GRADING AND DRAINAGE PLAN FOR TRACT X-1-A

SANDIA CREDIT UNION
GRADING AND DRAINAGE PLAN

C2

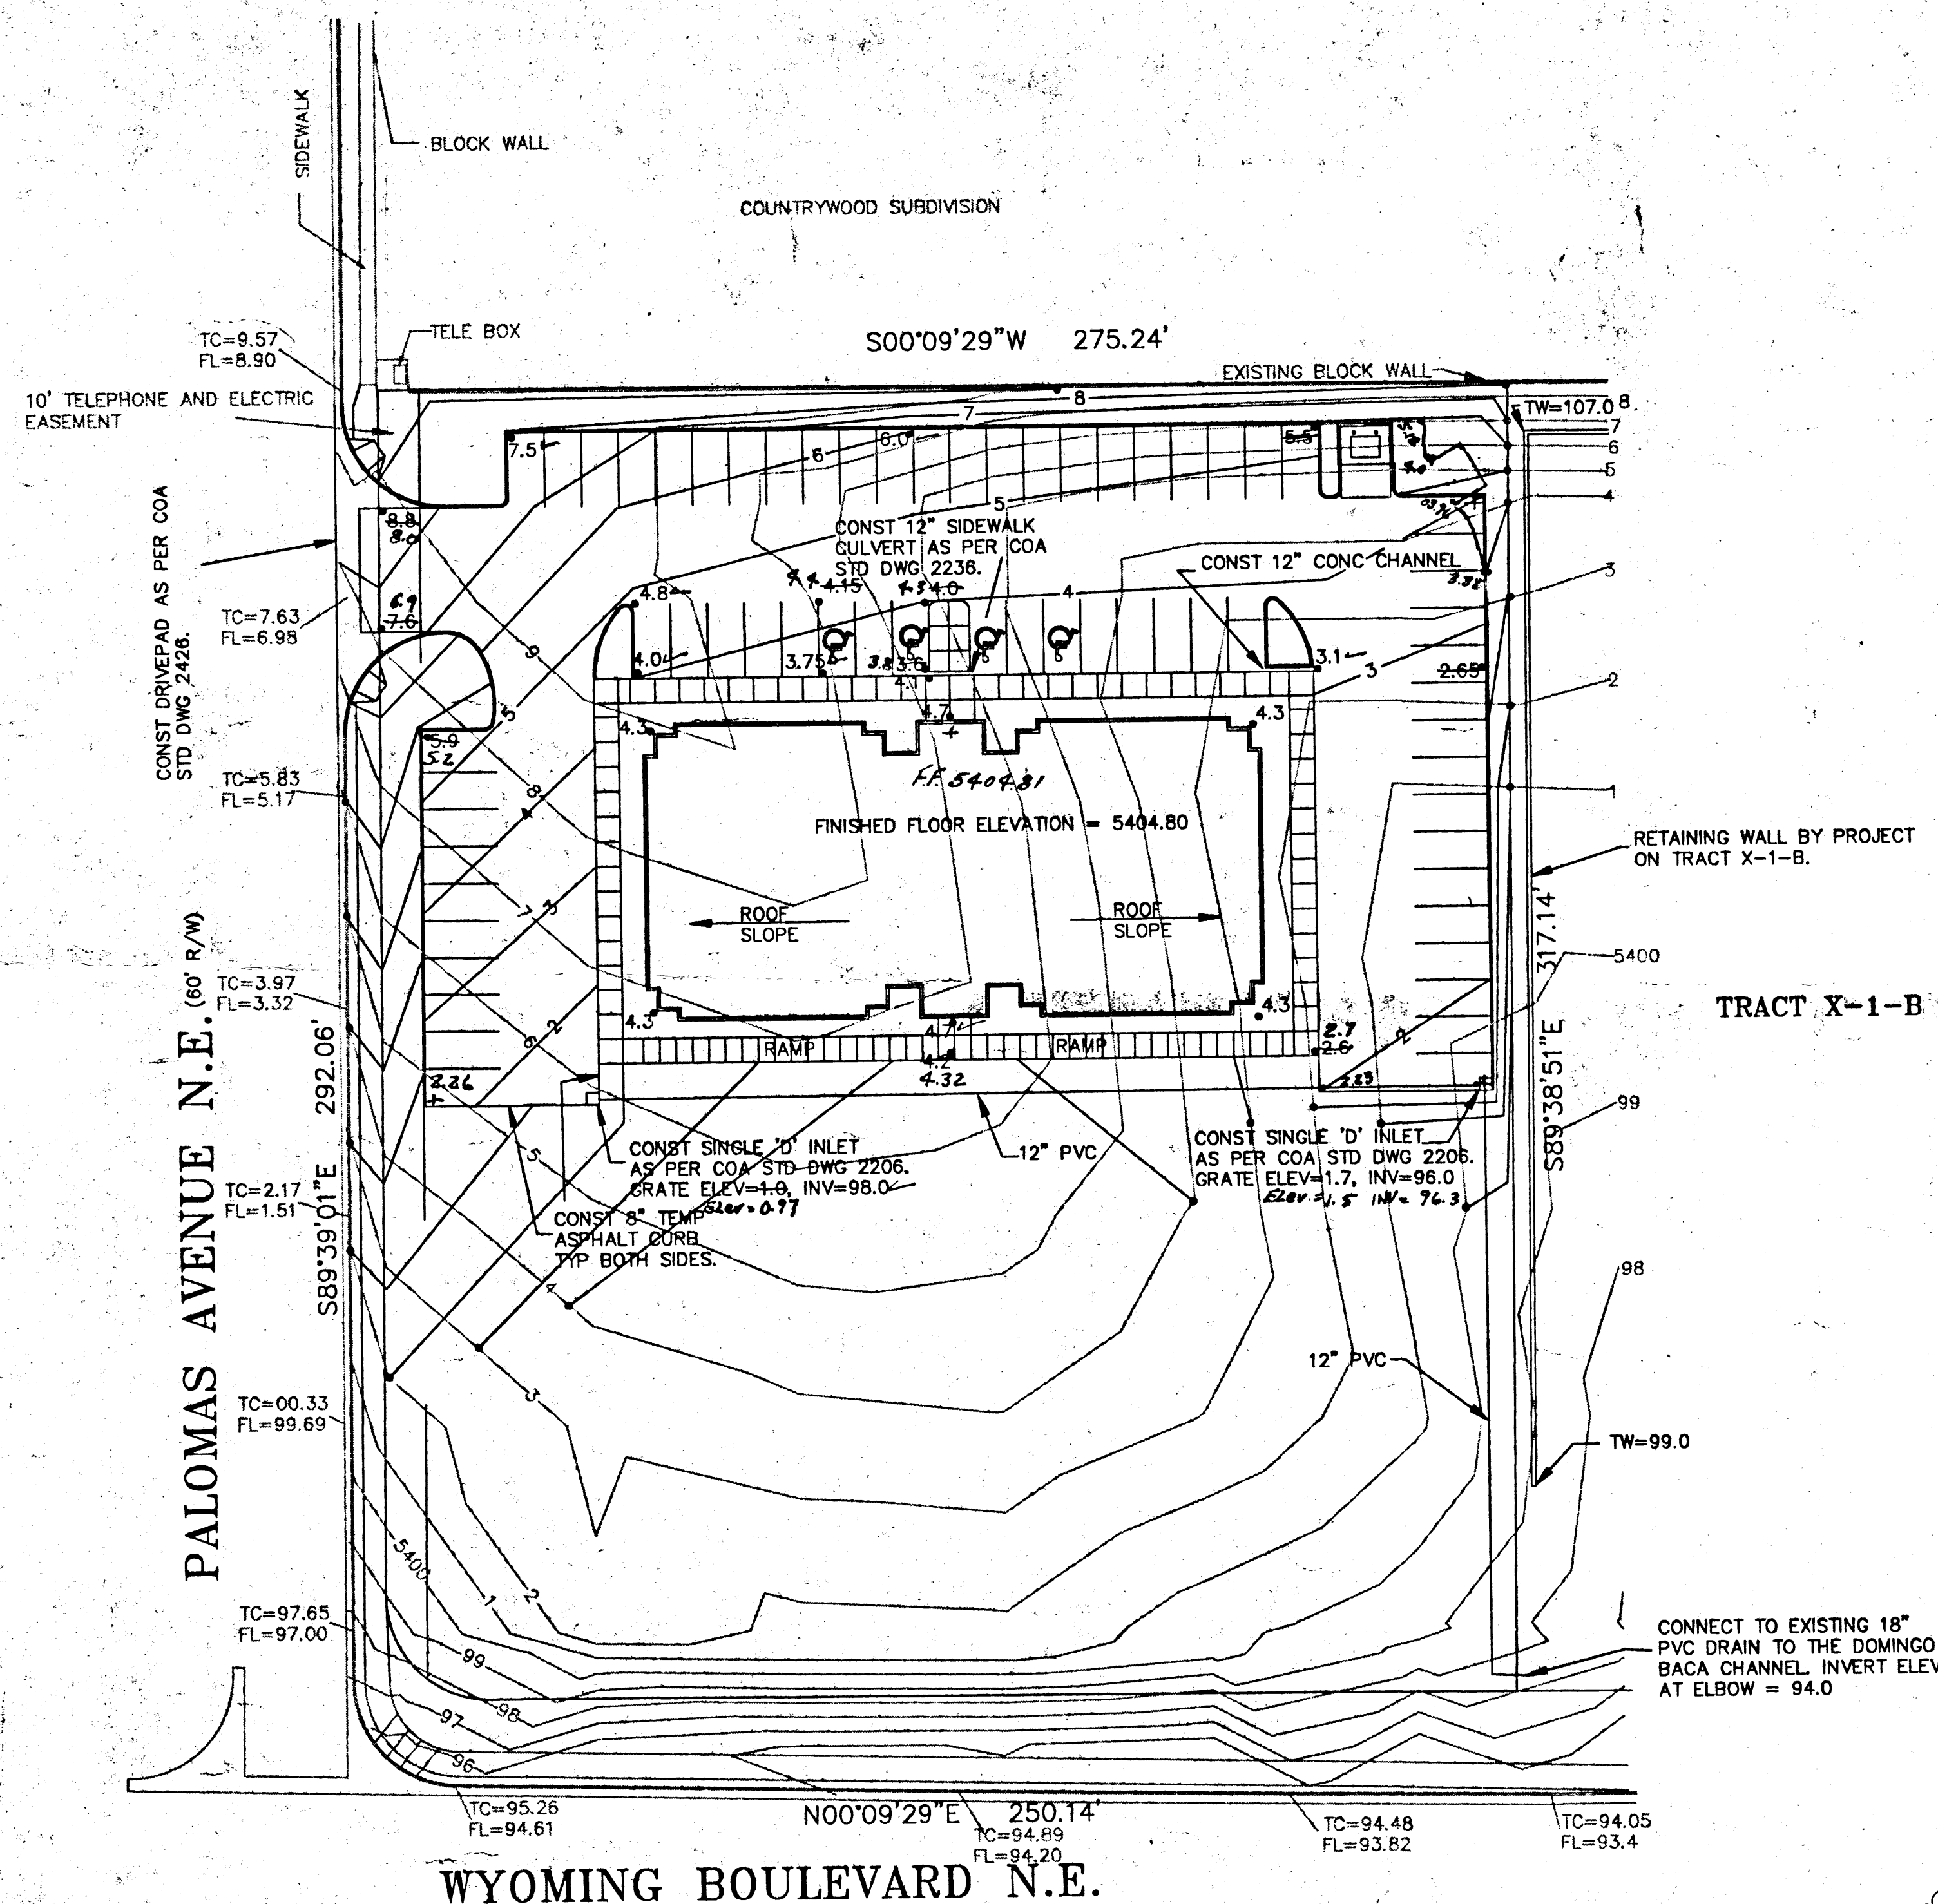
UNACCEPTABLE
9/1/99

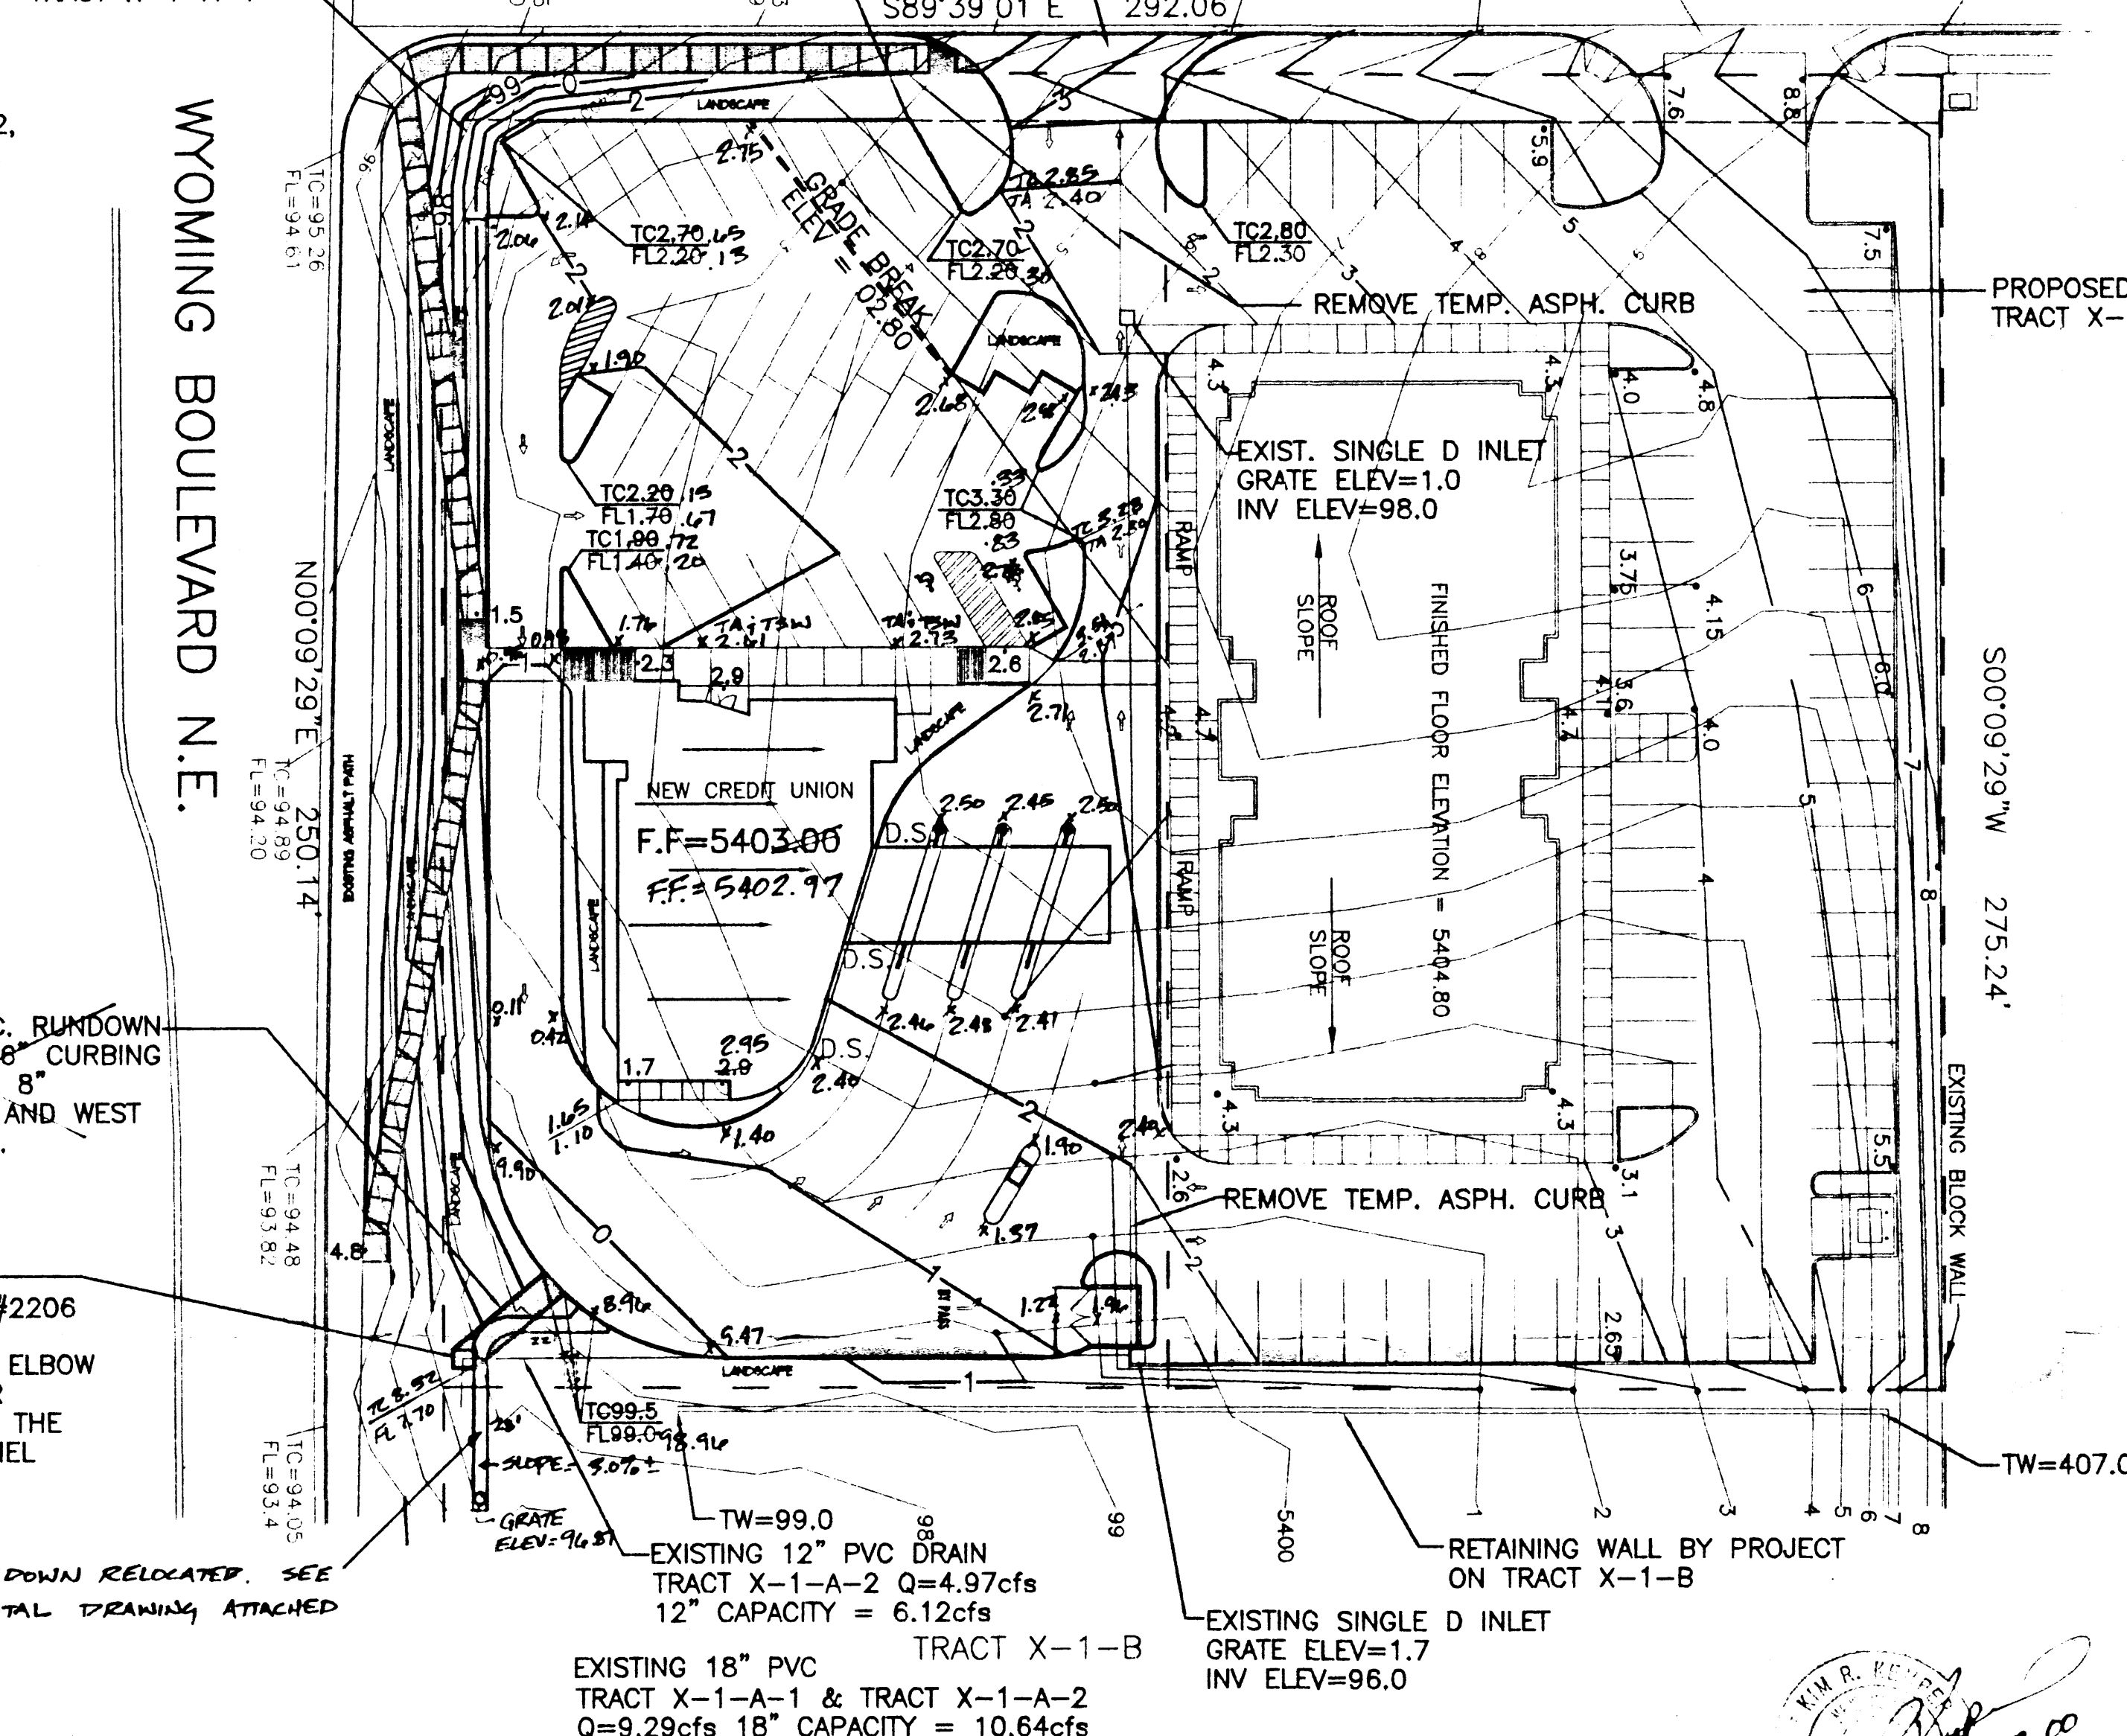
CONC. RUNDOWN RELOCATED. SEE
SUPPLEMENTAL DRAWING ATTACHED

This site is in substantial compliance with the approved grading and drainage plan with engineer's seal dated 7-14-99 (with the revisions as reflected in the record drawing elevations shown hereon). The site drainage will function as originally proposed.
